March 13, 2019

Comments re: Notice of Availability of the Draft Environmental Impact Statement for the Coastal Plain Oil and Gas Leasing Program and Announcement of Public Subsistence-Related Hearings, 83 Fed. Reg. 67,337 (Dec. 28, 2018).

¹⁸¹⁵ *See* Appendix D (Smith viewshed analysis at Figure 12).

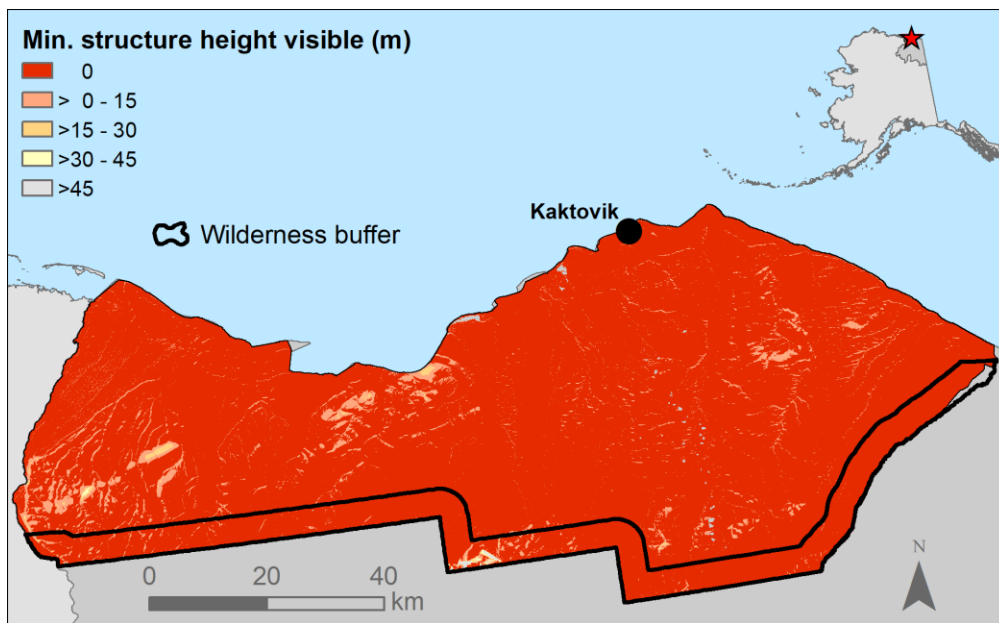
¹⁸¹³ DEIS vol. 1 at 2-1, Table 2-1.

¹⁸¹⁴ DEIS vol. 1 at 3-216.

¹⁸⁷¹ *See* Appendix D (Smith viewshed analysis at Figure 11).

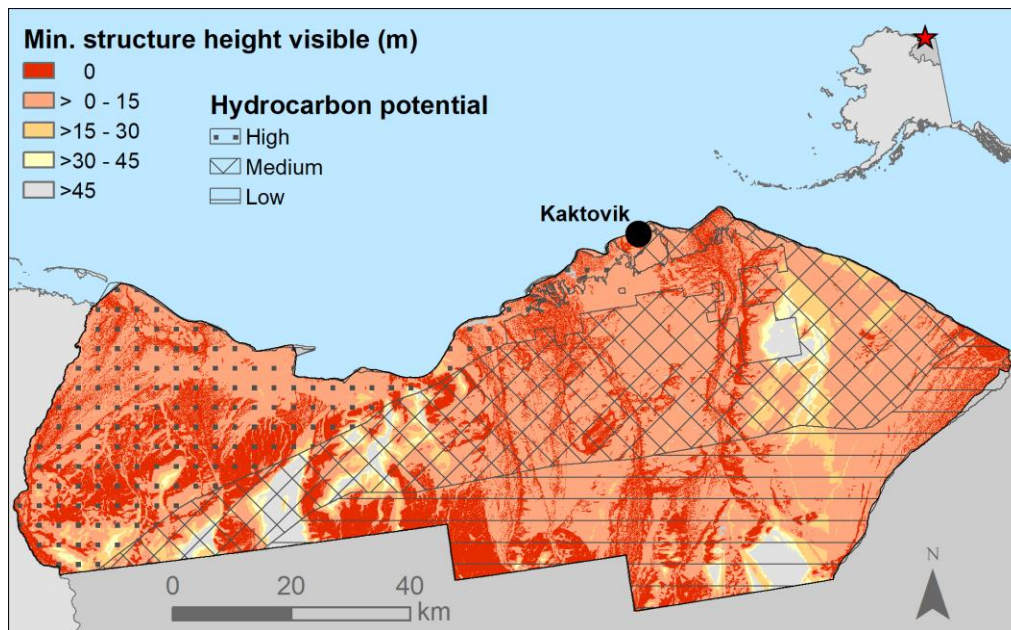
[T]he relatively flat topographic characteristics of the program area would result in new mineral development infrastructure being visible from far distances. Also, because there is no development currently, any new development that would be visible to recreation users would modify the recreation setting and visitor experiences.¹⁸⁶⁹

Nevertheless, the DEIS goes on to make a number of unsupported conclusions that NSO and other proposed measures would limit visual resource impacts, safeguard recreational settings and opportunities, and preserve wilderness character.¹⁸⁷⁰ Had BLM conducted the necessary visibility analysis, it would have demonstrated the inadequacy of the proposed stipulations. For instance, it would be virtually impossible to locate derricks and towers over 30 meters tall anywhere on the Coastal Plain without having them be visible from six major recreational river corridors.¹⁸⁷¹ And to avoid viewshed impacts from those six river corridors, infrastructure of 15 meters or less in height would need to be located within a small 12% of the Coastal Plain.¹⁸⁷² Notably, those limited locations that might shield infrastructure of less than 15 meters in height from the major river corridors include virtually no overlap with the high potential area and little overlap with whatever might reasonably be defined as the “medium potential area south of Kaktovik,” which according to BLM’s Reasonably Foreseeable Development Scenario would be the likely location of 3 of the 4 central processing facilities (CPFs) under Alternatives B, 2 of the 3 CPFs under Alternative C, and both CPFs under Alternative D:¹⁸⁷³
